PLANNING NMA-CHANGE LIST		
ID	Proposed Changes to plans that are 'Non Material'	Reason for 'Amendment'
A	Changes to Common stair towards compliance for general access where a clear landing needs to be provided and to accommodate smoke control. Circulation area and internal doorway to stairs rearranged to adapt corridor aisle. Stairs, structurally stacked for construction leading towards the corridor or lobby next to the stair being provided with a smoke vent and a store area provision on ground level. Rearrangement in plan due to the above visible on the Northeast facade. Window openings, adapted to suit mentioned changes/rearrangement.	Compliance towards Building Regulations, Part-K-Protection from falling, collision and impact and Part-B-Fire safety
B	Changes to Communal lifts and stairs towards compliance for firefighting where a firefighting shaft is required as the building is over 18m and to accommodate smoke control and building services. Circulation area internal doorway to stairs and clear landing for lifts rearranged to adapt corridor aisle. Stairs, structurally stacked for construction leading towards a vertical smoke shaft that opens at roof level with rationalised comm

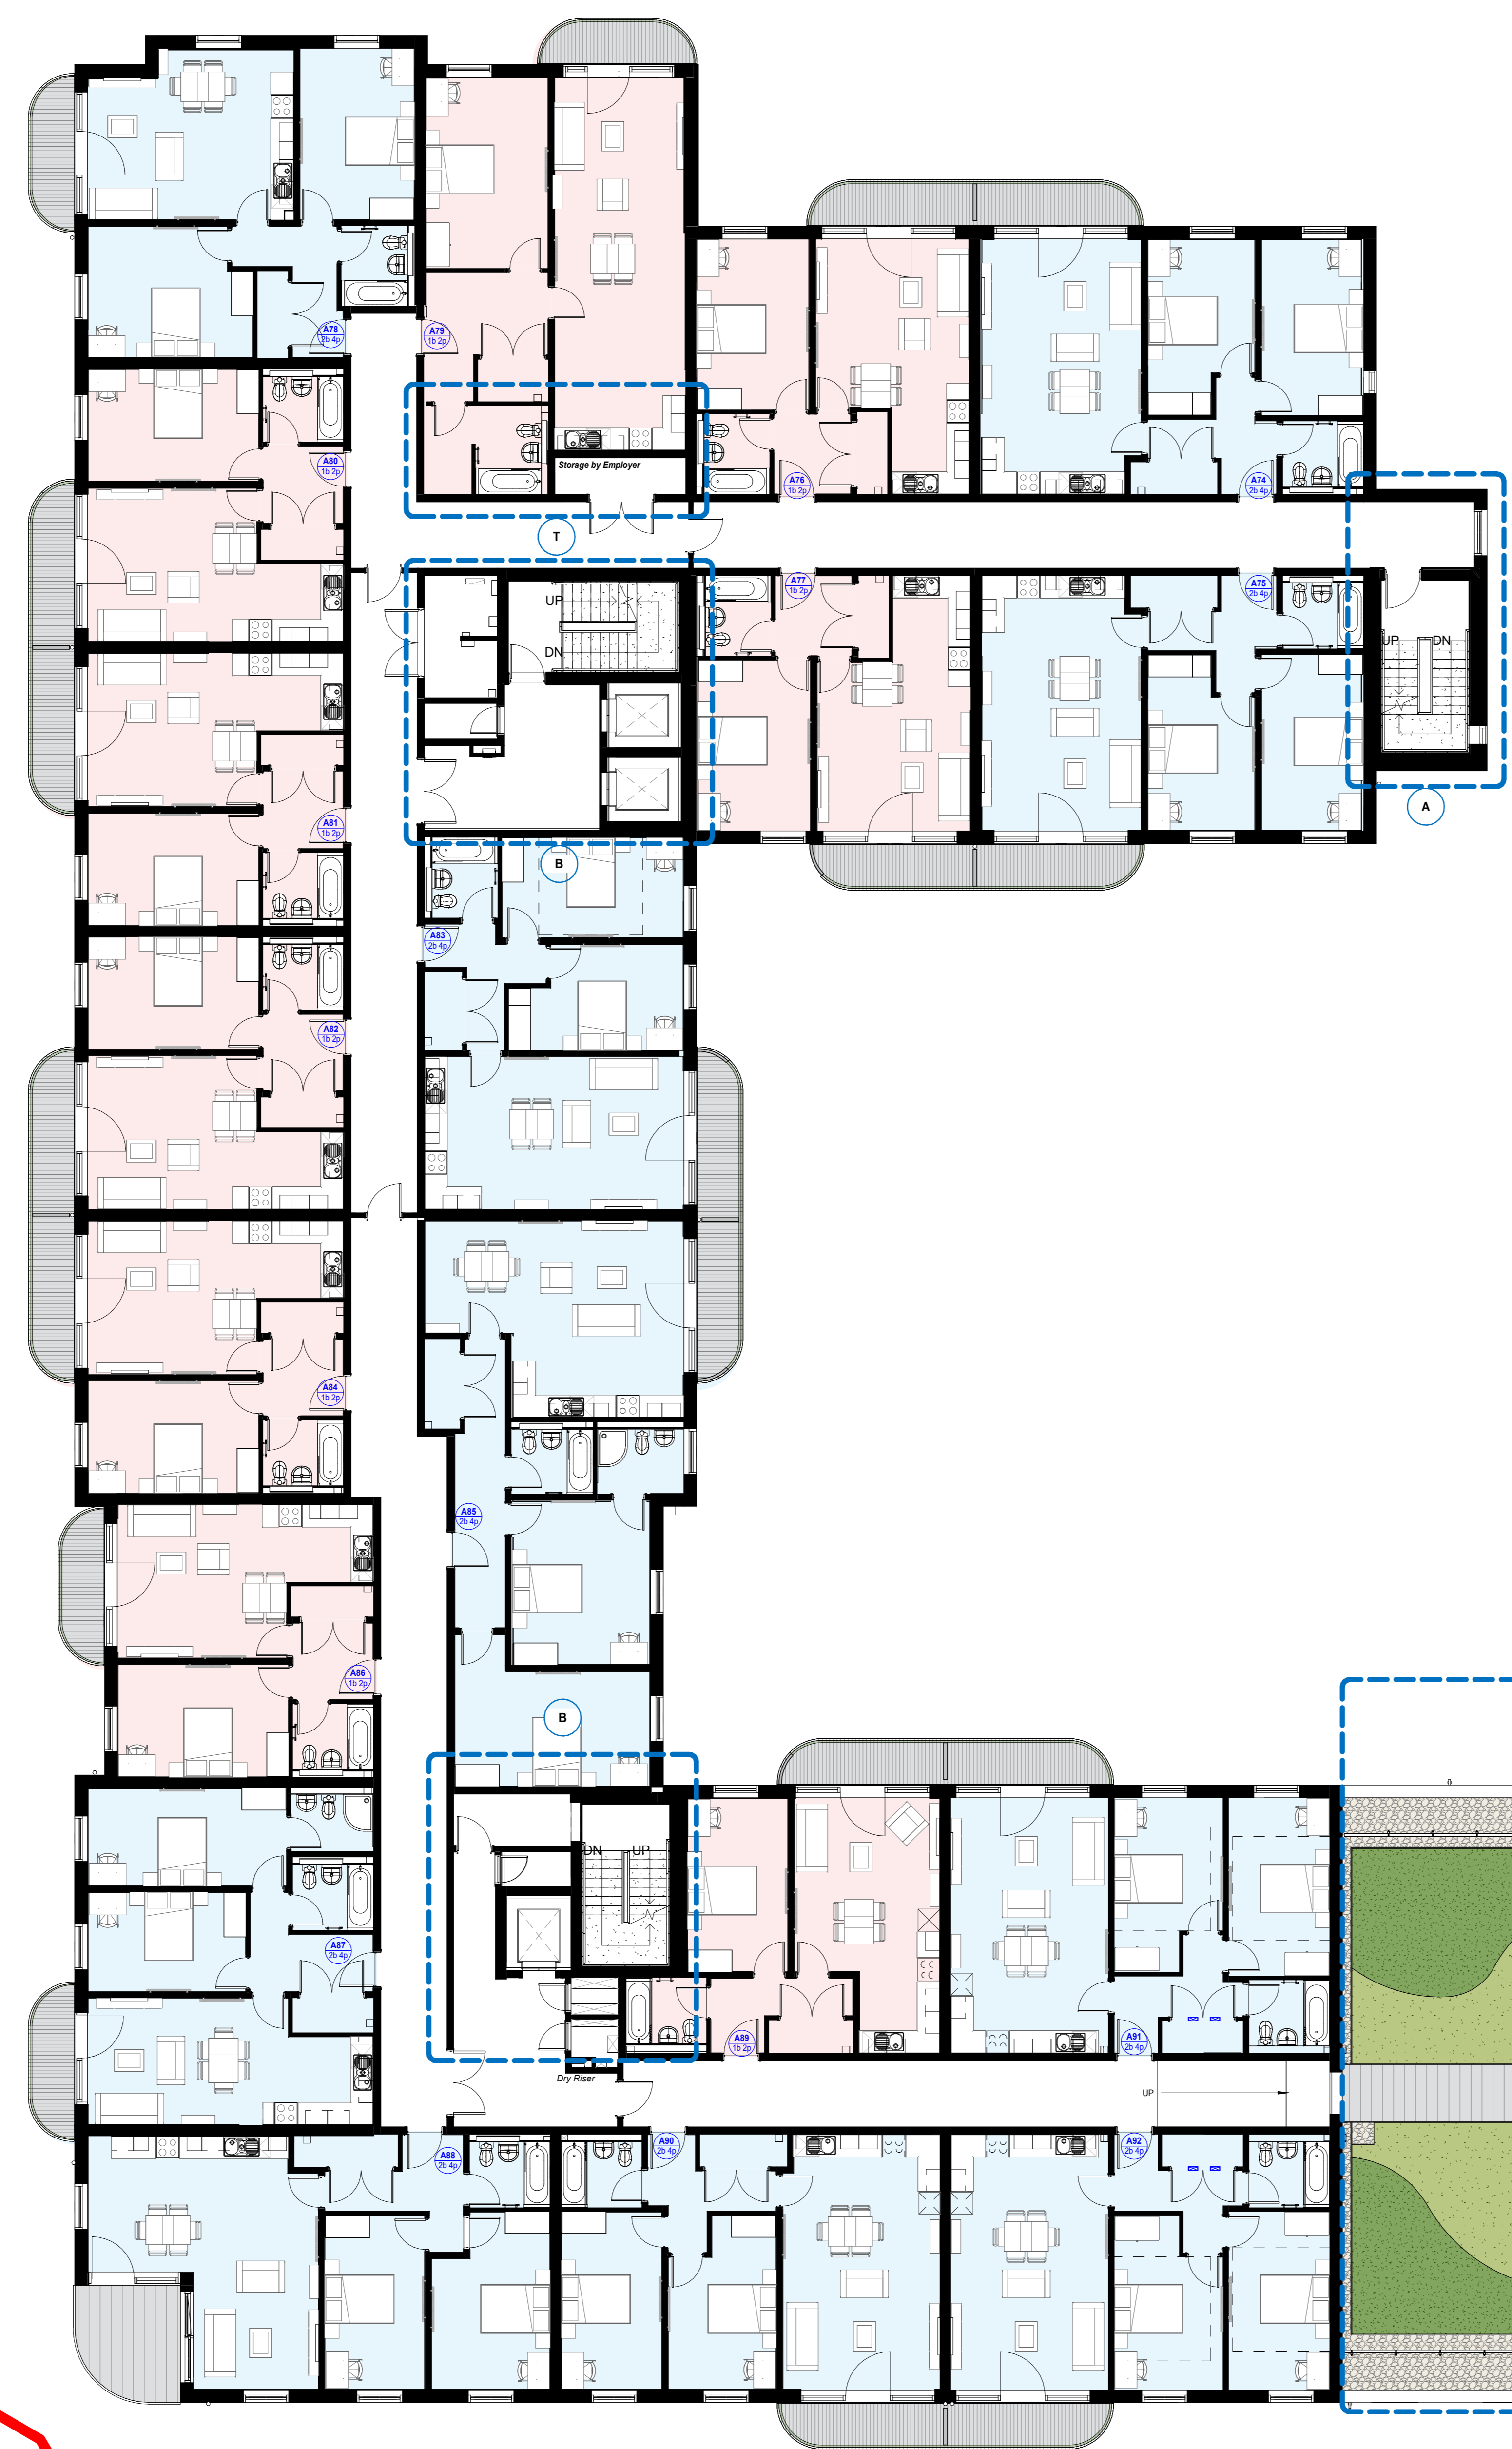
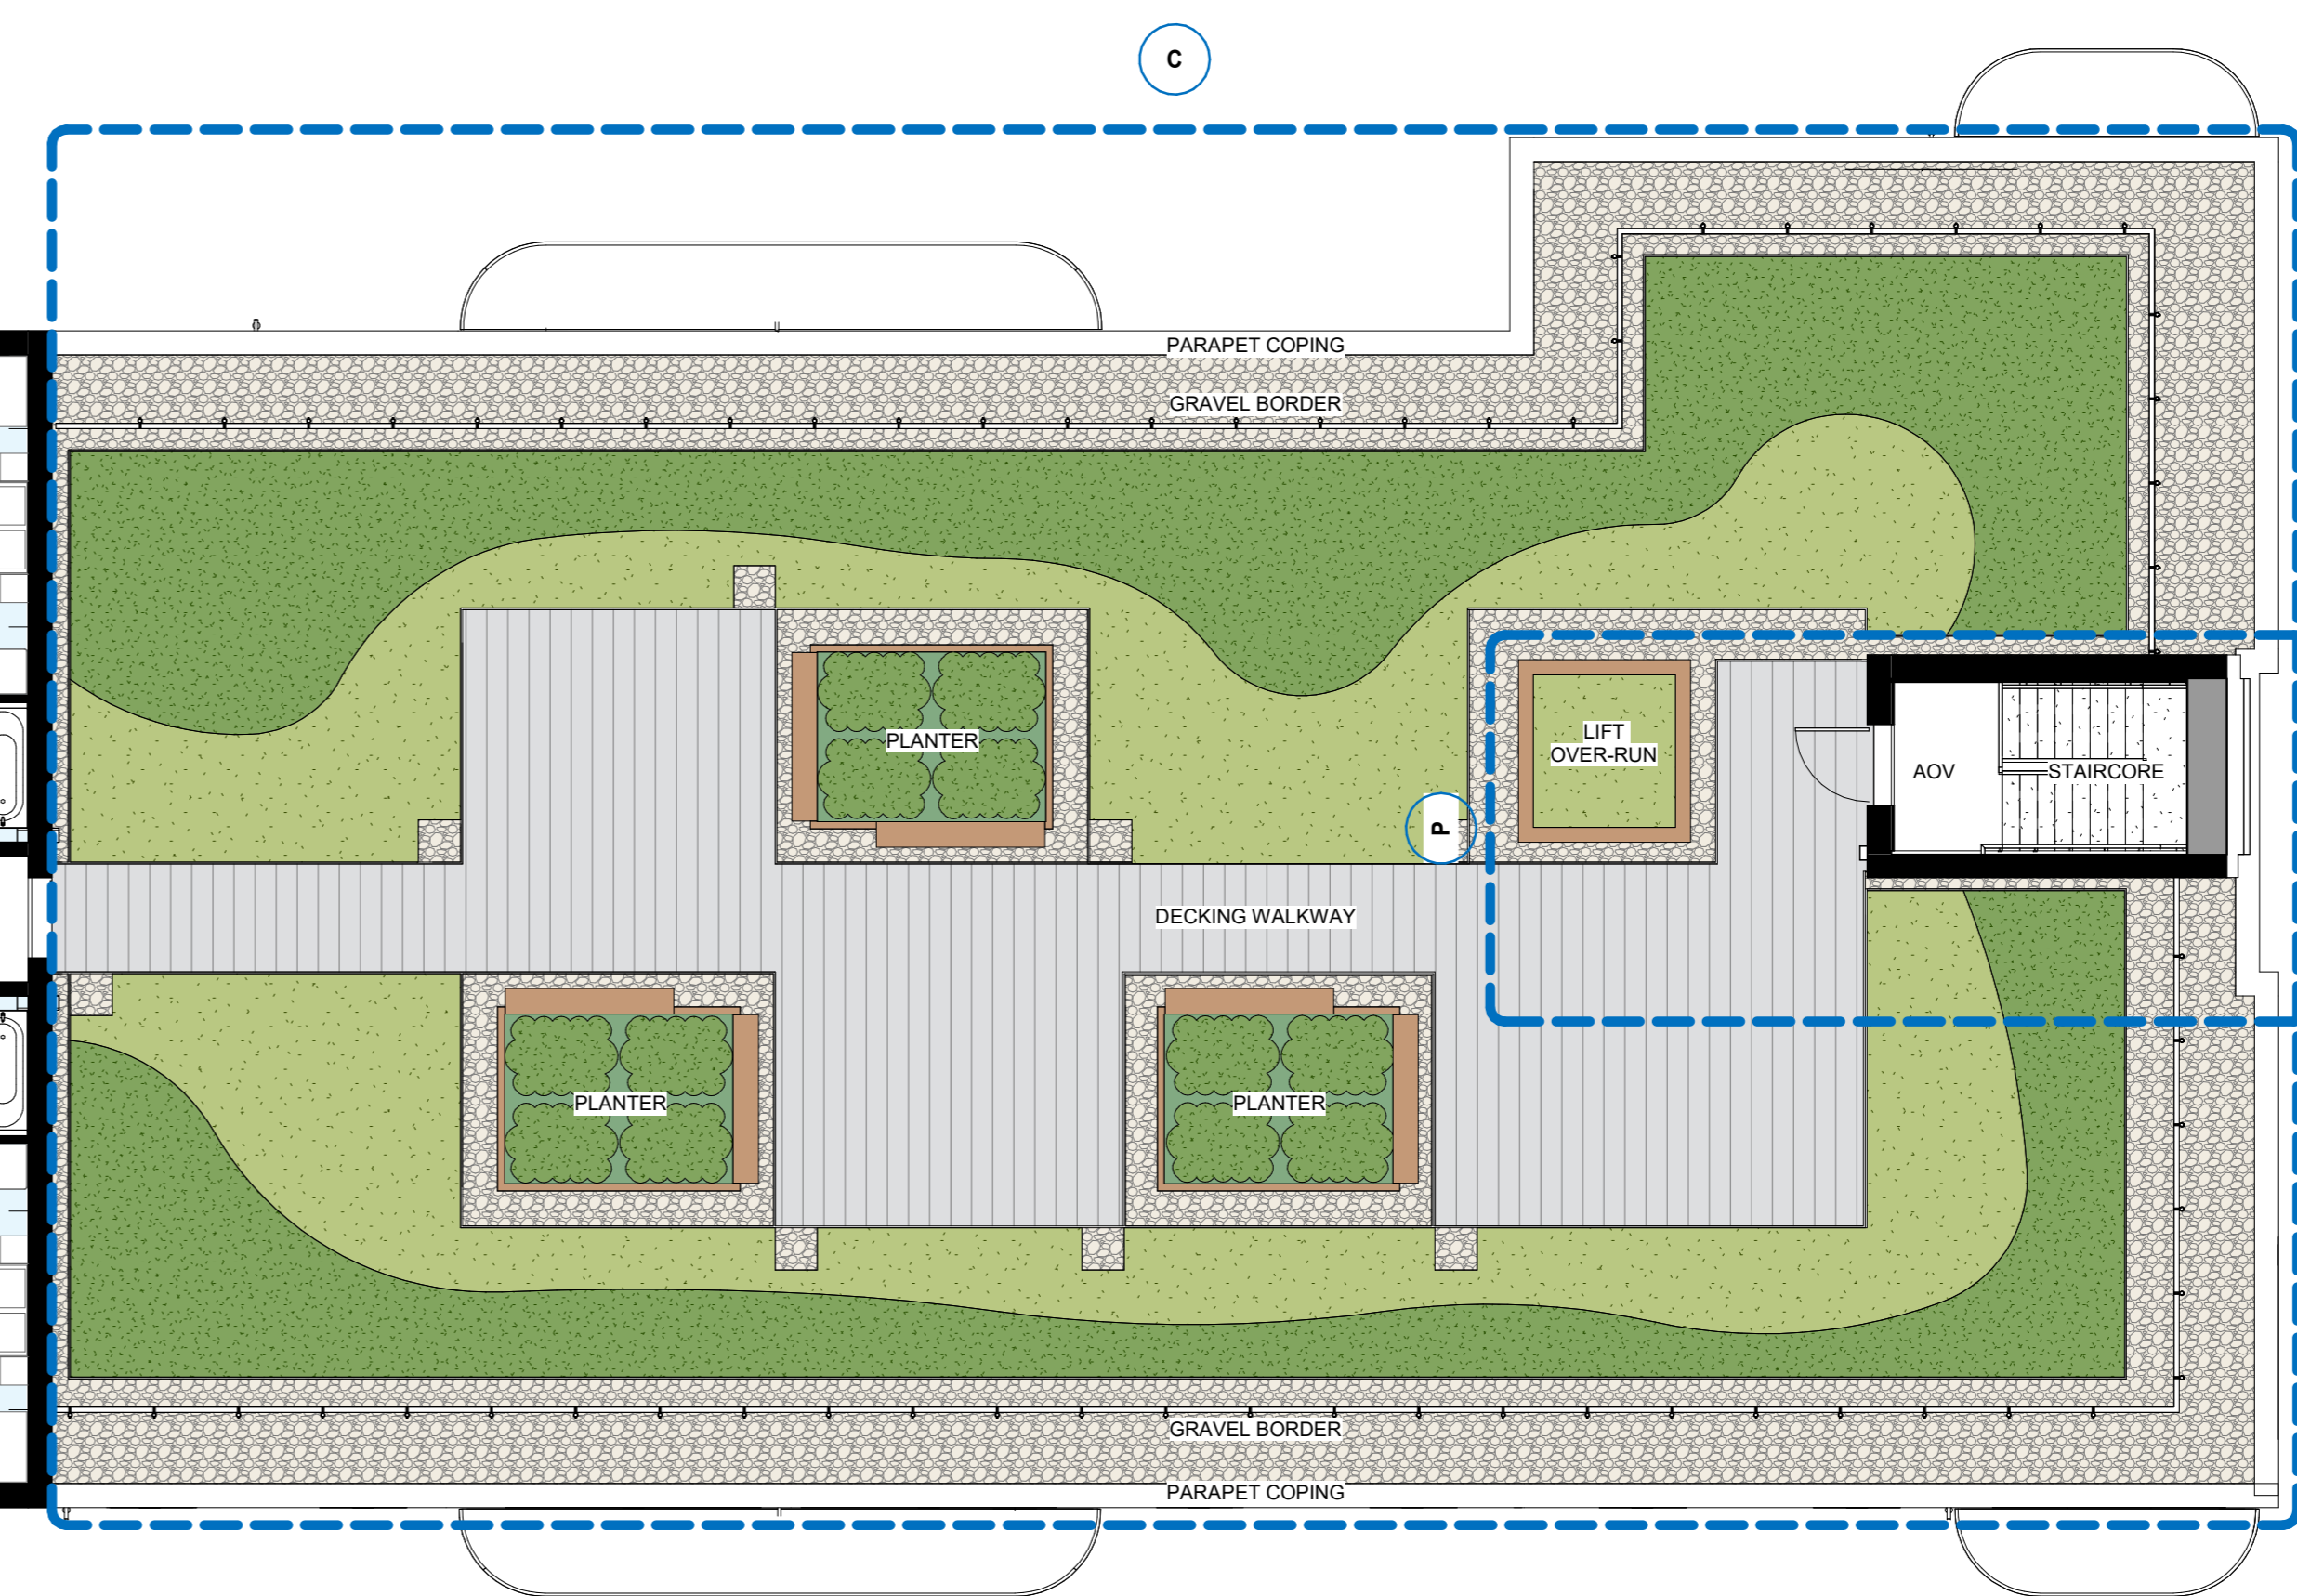
C	Changes to communal roof gardens (landscaping) including change of barrier type (railing) from glazed balustrade to counterbalance metal railing.	To contribute positively towards biodiversity via balance of soft and hard landscaping schemes including provisions for bird and bat boxes, whilst maintaining overall uniformity for railing type.
D	Removal of photovoltaic (PV) cells on the roof	PV was not required as Part L requirement was met using Exhaust Air Heat Pumps.
E	Relocation of Substation and provision for Generator in allocated space.	Provision for separate secluded area for generator
F	Changes to provide new location for UKPN Substation	Provision for future relocation for UKPN Substation
G	Changes to ground level Cycle store to accommodate building services plant rooms including removal of two openings with rearrangement of the remainder openings.	Provision towards Building Services, Secondary LV switch room and Comms room.

H	Changes to ground level Cycle store to accommodate building services plant rooms including removal of two openings with rearrangement of the remainder openings.	Provision towards secure access and splitting into 4 small bin stores to comply with recent updates of having maximum 8 large (1100lrs) receptacles within.
J	Removal of Cycle store area and Bin store area at ground level, including external door in cycle store area towards provision to accommodate building services plant room including clear vehicular access towards undercroft parking.	Provision towards Building Services, Primary LV switch room and vehicular access towards undercroft parking.
K	Changes to ground level facade including removal of two openings to accommodate communal letter boxes with rearrangement of the remainder openings with provision for accessibility.	Provision towards communal letter boxes
L	Removal of undercroft parking entrance/exit at ground level towards provision for Relocation/Retainment of existing UKPN Substation, whilst adding double doors as per change ID-C-05.	Provision towards single point of entry/exit for undercroft parking and towards relocation/retainment of existing UKPN Substation mentioned in change ID-E.

M	Changes to ground and first floor level, Common stair for means of fire escape and to accommodate smoke control to circulation area. Circulation area and internal doorway to stairs rearranged to adapt corridor aisle. Stairs, moved away from corridor aisle leading towards provision for an external smoke vent at first floor level. Rearrangement in plan due to the above visible on the Northeast facade. Ground level escape door, adapted to suit mentioned changes/rearrangement.	Compliance towards Building Regulations, Part-B-Fire safety.
N	Changes to ground level Cycle room and adjacent Store to replace provision for Cycle store area as per change ID-C-09 via consolidation. Rearrangement in plan due to the above visible on elevations.	Provision towards replacement of removed cycle store mentioned in change ID-J.
P	Changes to Communal lift and stairs towards compliance for general access where a clear landing needs to be provided and to accommodate smoke control and building services. Circulation area internal doorway to stairs and clear landing for lifts rearranged to adapt corridor aisle. Stairs, structurally stacked for construction leading towards covered and enclosed stair at roof fourth floor level with rationalised communal entrance/exit. Rearrangement in plan due to the above visible on elevations.	Compliance towards Building Regulations, Part-K-Protection from falling, collision and impact, Part-B-Fire safety and Provision for stair enclosed/walkway that is directly covered.

Q	Changes to ground level Bin store arrangement to replace Bin store as per change ID-C-09 via consolidation and enlargement to provide building services plant room. Rearrangement in plan due to the above visible on elevations.	Provision towards replacement of removed Bin store mentioned in change ID-J and provision for BCW Tank room
R	Changes to ground level openings, facade screens from circular pattern metal screens/vents to vertical extruded aluminium flats metal screen that match the railing type, including removal of one opening that clashes structural column on the corner way elevation.	To maintaining overall architectural uniformity and structural framing.
S	Removal of Green Wall as they do not comply with fire safety regulation 7(2).	Regulation 7(2), requires all residential blocks with top-storey heights over 18m to have all materials which become part of an external wall or specified attachment (e.g., balconies) to achieve class A2-s1, d0 or class A1, except for materials which are exempt as per regulation 7(3). Additionally, membranes used as part of external wall construction above ground should achieve a minimum of class B-s3, d0.

T	Changes to storage area, rearrangement towards desired storage required.	Provision towards desired storage required.
U	Discrepancy error on Comet way elevation whereby two window openings depicted would not have been located on the fifth-floor level plan as these would intrude privacy for the bathrooms.	Discrepancy error
V	Removal of single window, recessed brick reveals on the Northeast elevation.	The recessed brick reveals is towards the left of a single pane window for levels 1-4, whilst it changes to a double pane for level 5. To maintain architectural uniformity, we have detailed a constant double pane window for all levels.
X	Private path on western site boundary	For Façade maintenance MEWP access.
